**SAAB****SERVICE INFORMATION**

SI No. 471-1743	Date June 1997	9000
PI No.	Distr. US, CA

New oil for manual gearboxes

All Saab 9000 M85- with manual gearbox

C471B002

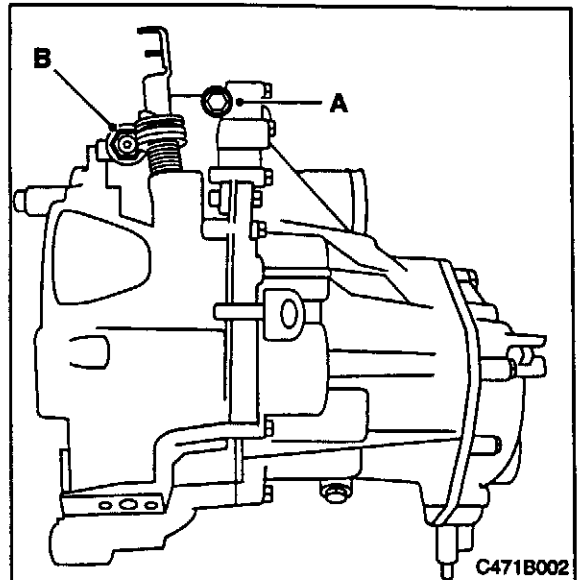
- 1 Drain the gearbox by removing plug A and using an oil suction pump.

If there is no plug A, the speedometer drive B can be removed. Clean thoroughly around its fitting before removing it. Use tool 87 90 917 to lift up the speedometer drive from the gearbox.

C471B003

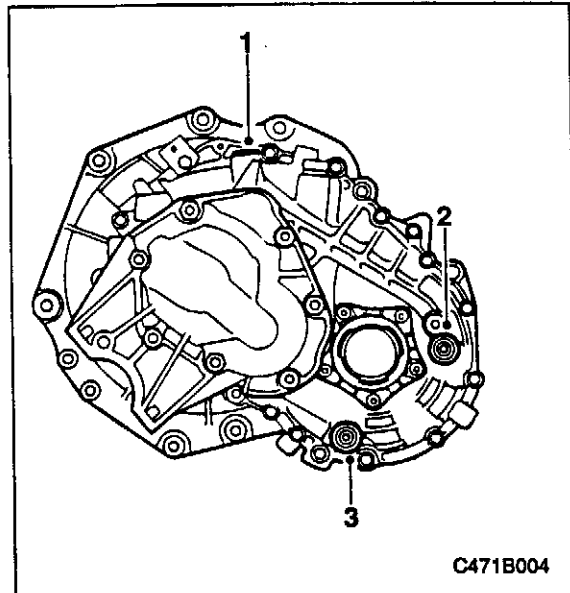
- 5 There are two labels on the neck of the oil carton that must be affixed to separate places as a reminder of the type of oil in the gearbox.

- 6 Clean the area around the radiator crossmember by the left-hand headlamp, remove the label with the warning triangle and affix it to the radiator crossmember.

- 7 Remove the small label and affix it over the existing text on gearbox oil in the owner's manual under the section "Technical data".
